**SUBJECT:** NuScale Power, LLC Response to NRC Request for Additional Information No. 8776 (eRAI No. 8776) on the NuScale Topical Report, "Loss-of-Coolant Accident Evaluation Model," TR-0516-49422, Revision 0

## Response to Request for Additional Information Docket: PROJ0769

eRAI No.: 8776

Figure 2 Containment Heat Transfer Mechanisms during a LOCA

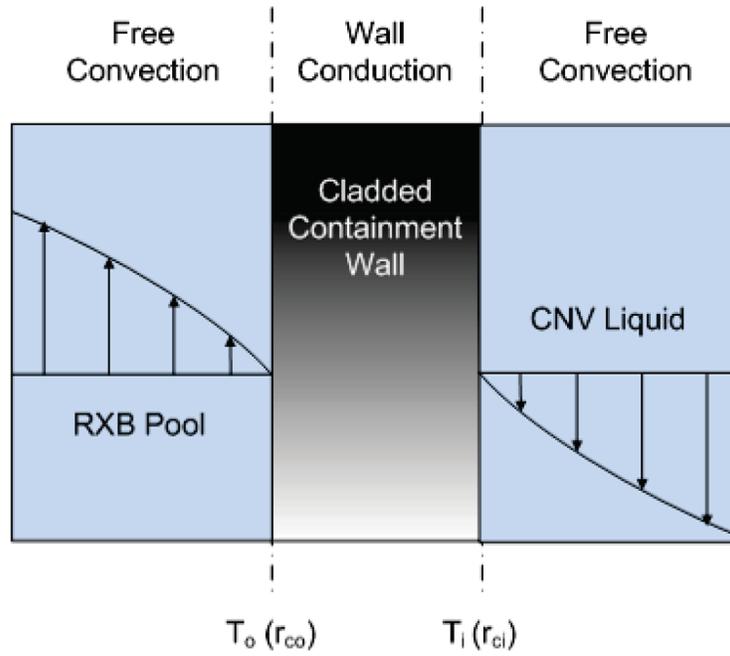
During a LOCA, the high energy fluid released from the Reactor Pressure Vessel (RPV) largely condenses on the containment wall near the top of the Containment Vessel (CNV). The condensate will form a film and flow down the CNV wall. With the condensate film insulating the steam from the wall, less condensation is expected at the lower CNV elevations. In addition, temperature differences between the RPV outside surface and the CNV inside surface will cause heat transfer on both surfaces to be different in the radial direction. With the spatial

}}<sup>2(a),(c)</sup> The staff is requesting the applicant to provide additional justification as to why a one-dimensional model adequately captures the 3-D effects of the fluid flow within containment.

Although the initial containment vacuum is maintained, a certain amount of the non-condensable gas is present and the dissolved gas in the primary system coolant may appear during the blow-down process. In the LOCA topical report, TR-0516-49422, Section 8.2.8.2, "Technical Evaluation," the applicant states, {{

}}<sup>2(a),(c)</sup> The staff is requesting the applicant to (1) provide additional information to support this statement and (2) evaluate the potential effect of dissolved reactor coolant system non-condensable gases on two-phase core water level and containment heat transfer upon emergency core cooling system actuation.

The analytical calculations presented in this section were performed as part of NIST-1 facility scaling analysis. Figure 2 schematically shows the heat transfer path from the CNV to ultimate heat sink. The steam vented from the RCS condenses rapidly on the inside surface of the CNV. CNV heat is transferred to the CNV inside surface, conducted through the CNV wall to the outside surface of the CNV, and then transferred by natural convection to the reactor pool.

Under steady state conditions, the rate of heat transfer from CNV to pool is represented by the following general equation:

The above analysis is applicable for steady state heat transfer from the CNV to the reactor pool. The time constant for the {{
